**ADDENDUM NUMBER: #2 - 190515**

Project Name: Fire Station #5

## Addendum

198001.000 | Edinburg Fire Station No. 5

**1 ROOF PLAN**  
MEP2.2  
1/8" = 1'-0"

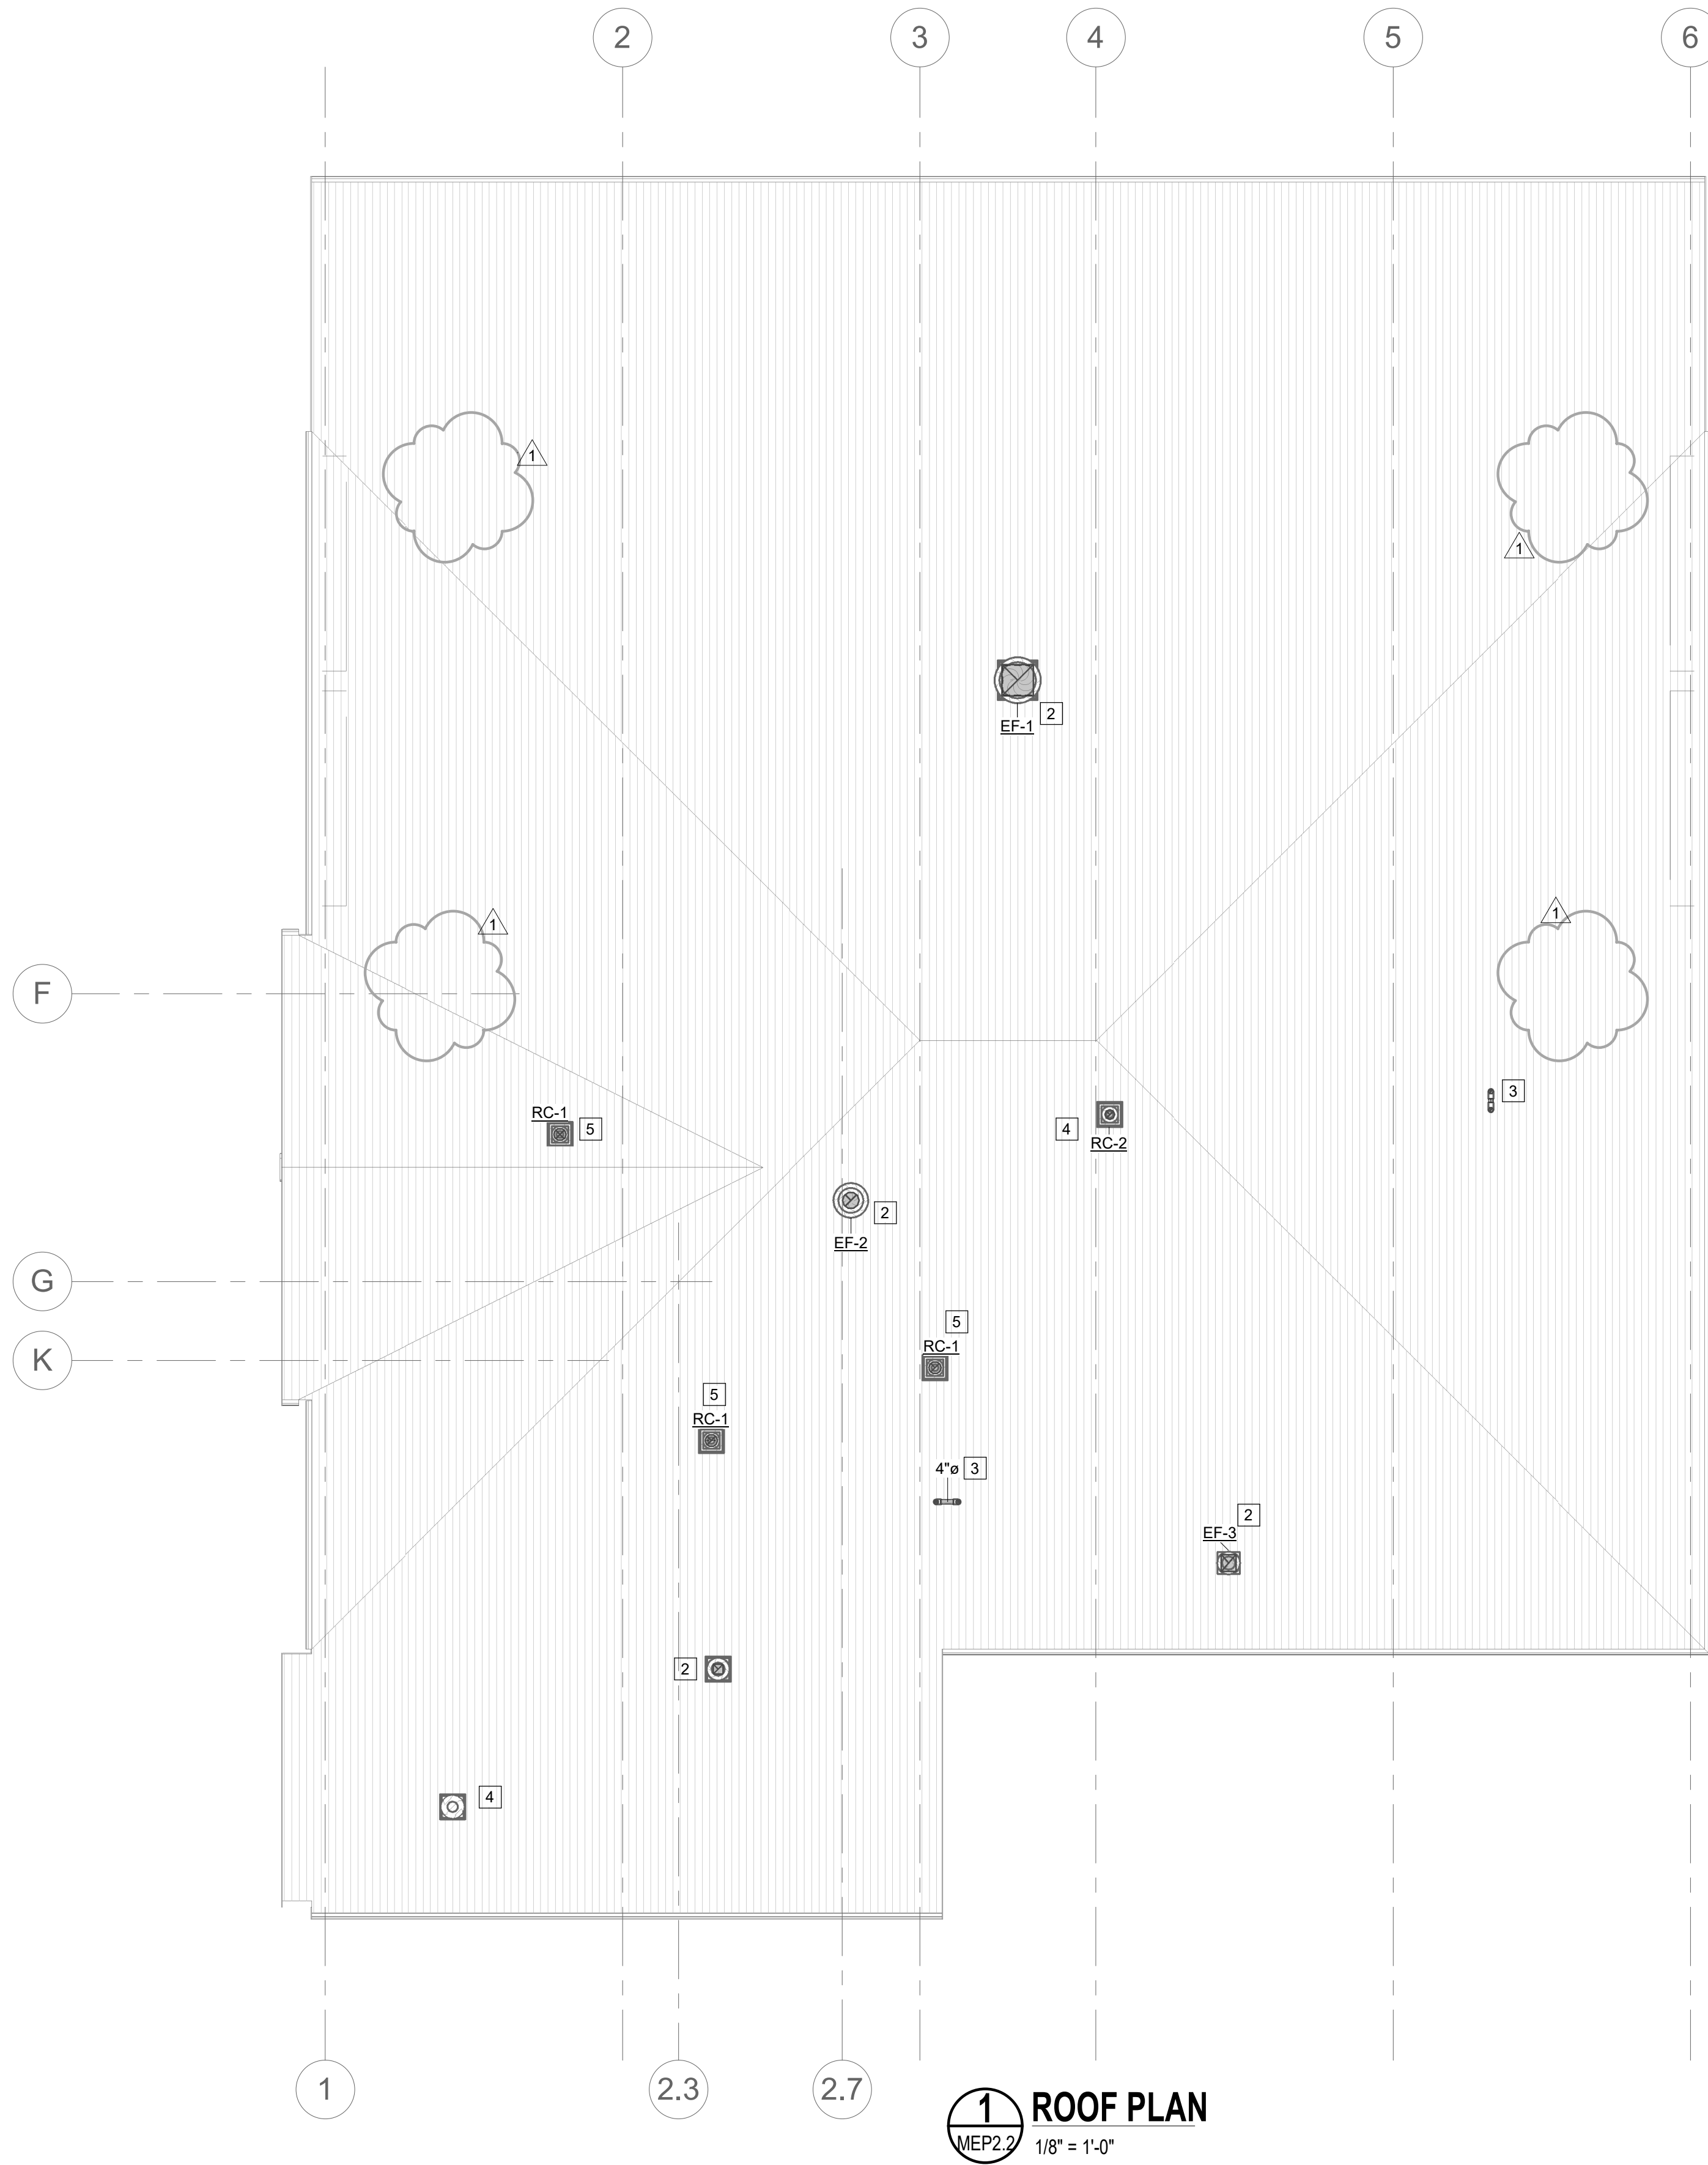
- A.      Omit flue vent through roof.
- B.      Disregard keyed note 1.

**1 MECHANICAL FLOOR PLAN**  
M2.1 1/8" = 1'-0"

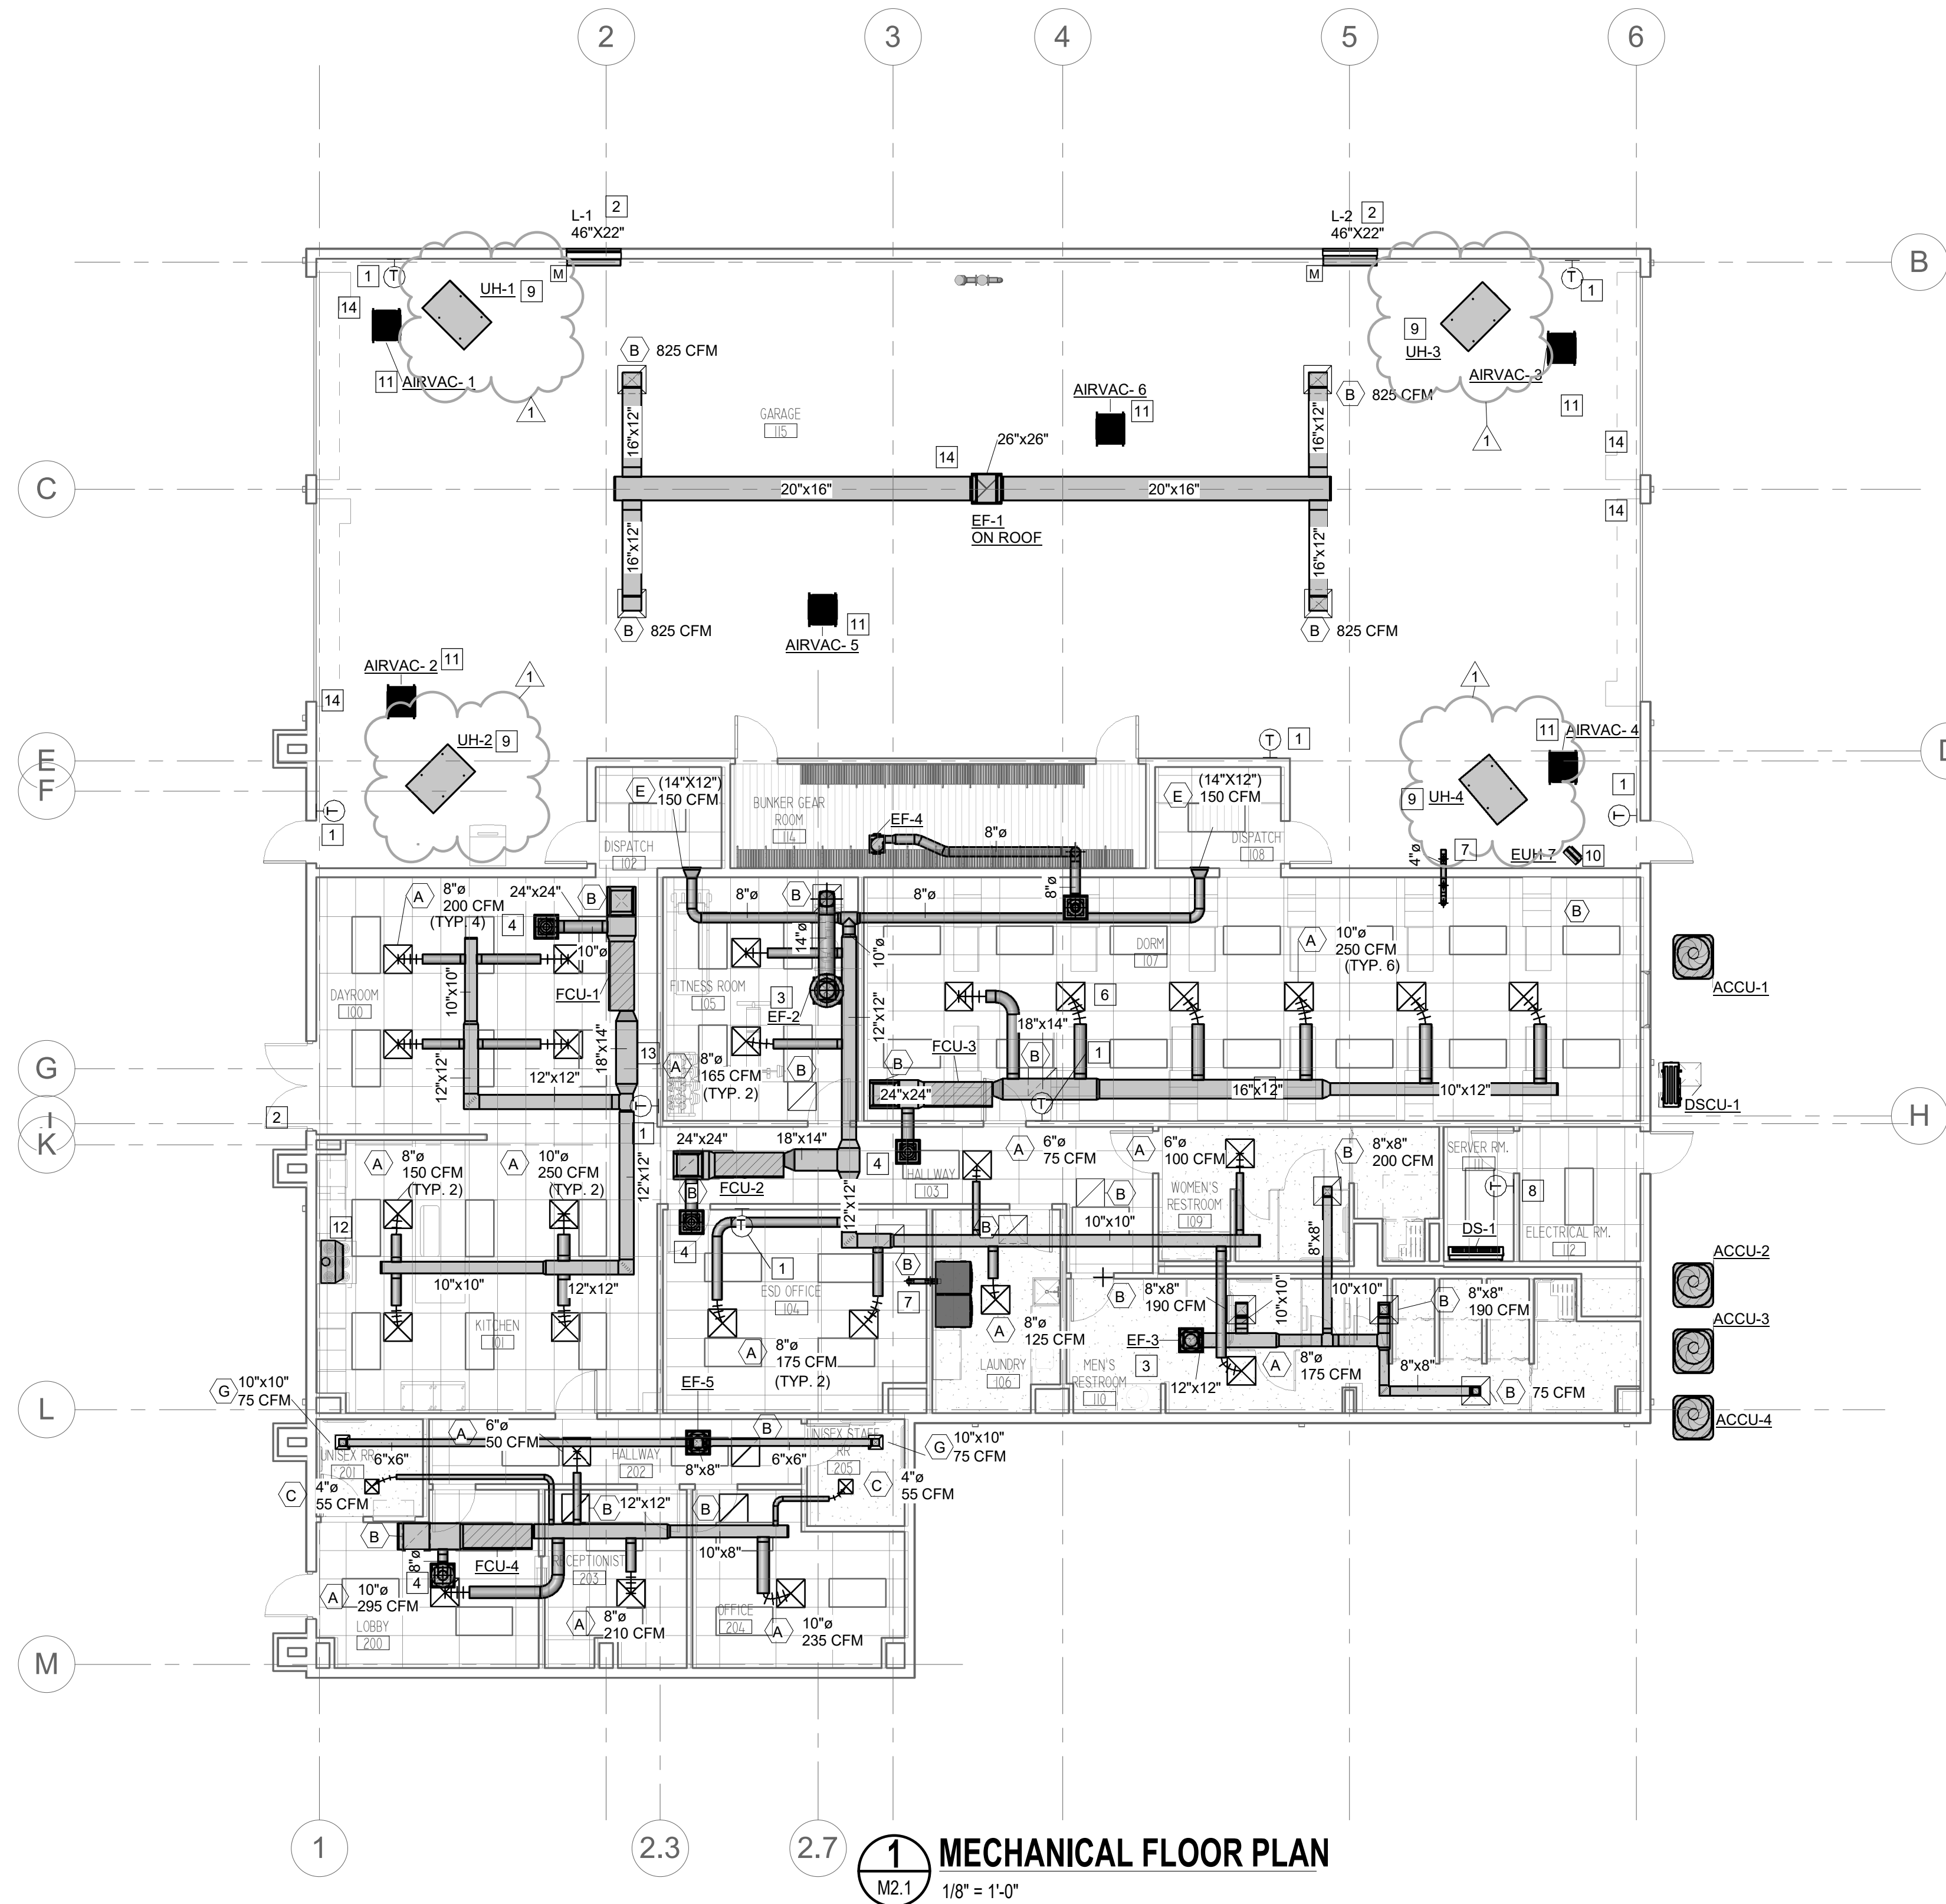
- A.      Replace gas unit heaters in Garage 115 with electric unit heaters. Revised keyed note 9. Refer to M2.1 and M5.0 for new schedule.
- B.      Omit flue vent through roof.

- 8 PROVIDE STAND ALONE HVAC CONTROLS PANELS. COORDINATE WITH ELECTRICAL AND CONTROLS CONTRACTOR PRIOR TO INSTALLATION.
- 9 INSTALL ELECTRIC UNIT HEATERS AS HIGH AS POSSIBLE AND AT A SLIGHT ANGLE DOWNWARD. HEATERS SHALL BE CONNECTED TO TSTATS WHICH WILL CONTROL WHEN THEY ARE ACTIVATED, TYPICAL FOR BAY.

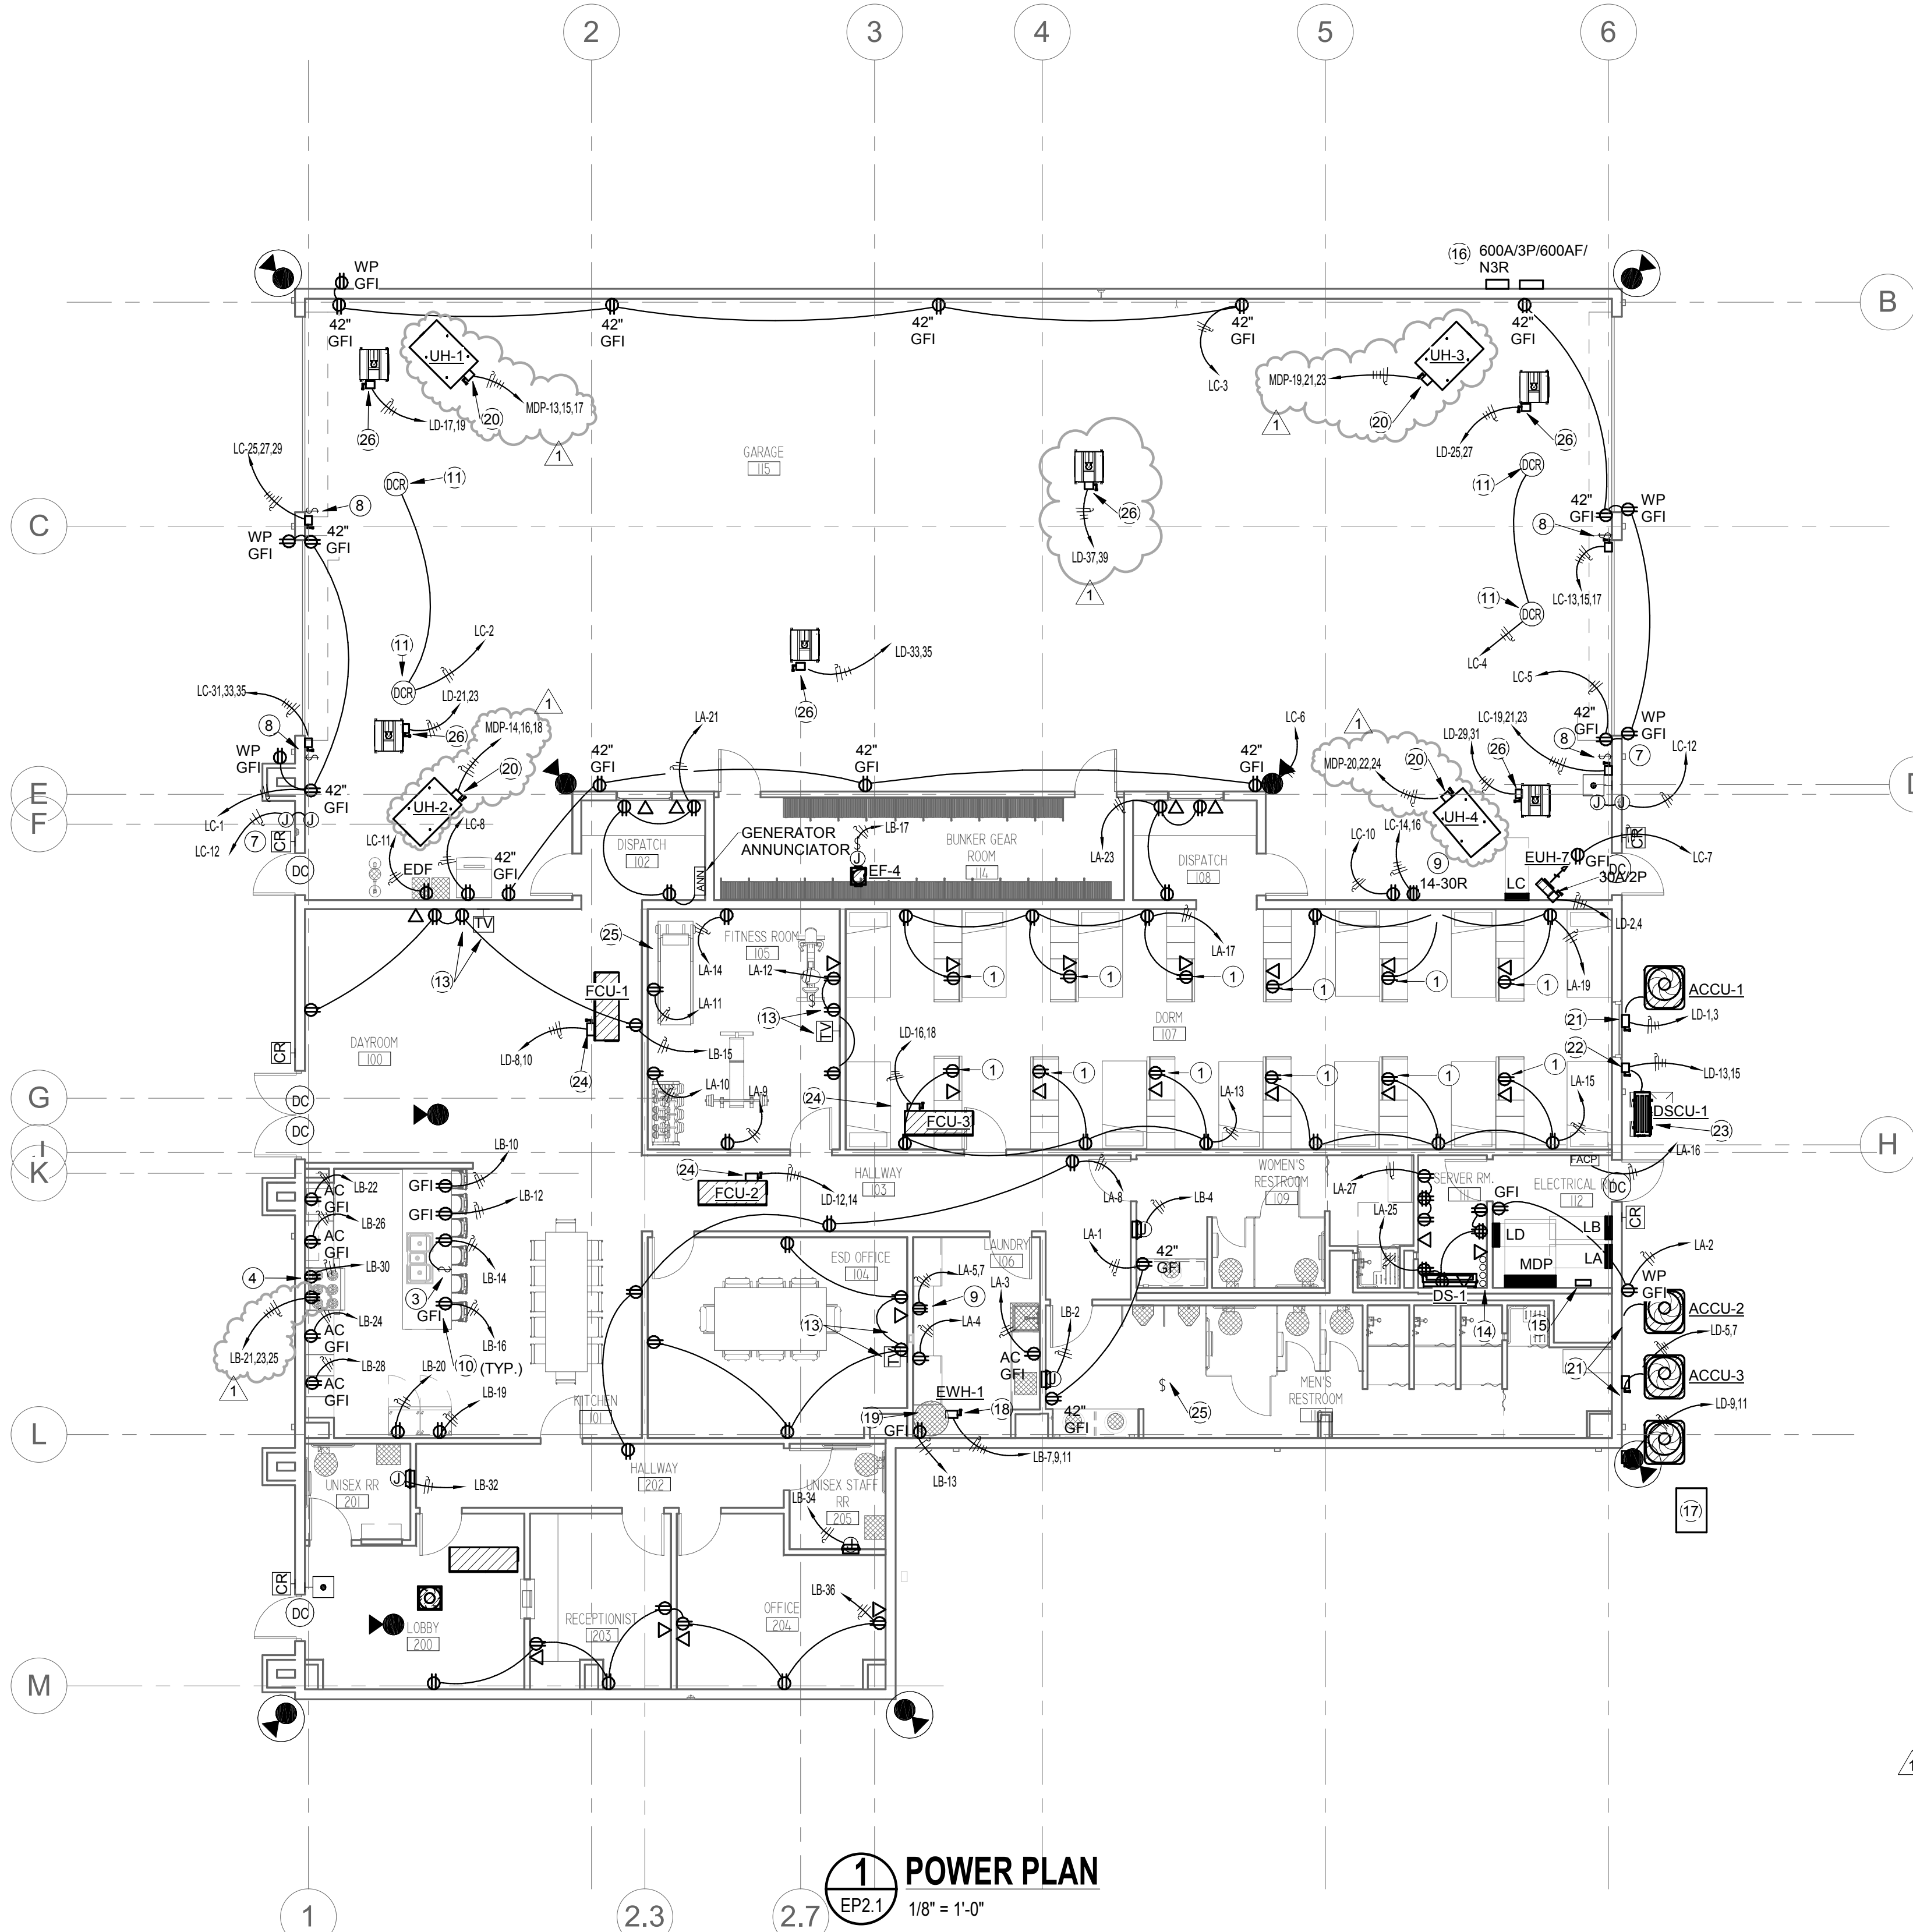
- A.      Revised gas unit heater schedule to electric unit heaters. Typ. Of 4 in Garage 115.

ELECTRIC UNIT HEATER SCHEDULE				
MARK	UH-1	UH-2	UH-3	UH-4
SERVES	BAY	BAY	BAY	BAY
CFM	800	800	800	800
KW / STAGES	15/1	15/1	15/1	15/1
VOLTS/PHASE/HERTZ	208/3/60	208/3/60	208/3/60	208/3/60
MCA	41.7	41.7	41.7	41.7
MANUFACTURER	REZNOR	REZNOR	REZNOR	REZNOR
MODEL NO.	F3FUH15CO3	F3FUH15CO3	F3FUH15CO3	F3FUH15CO3
NOTES	1	1	1	1
NOTES:				
1. PROVIDE WITH SUMMER FAN SWITCH, DISCONNECT SWITCH, BUILT-IN THERMOSTAT, WALL/CEILING SUSPENSION KIT.
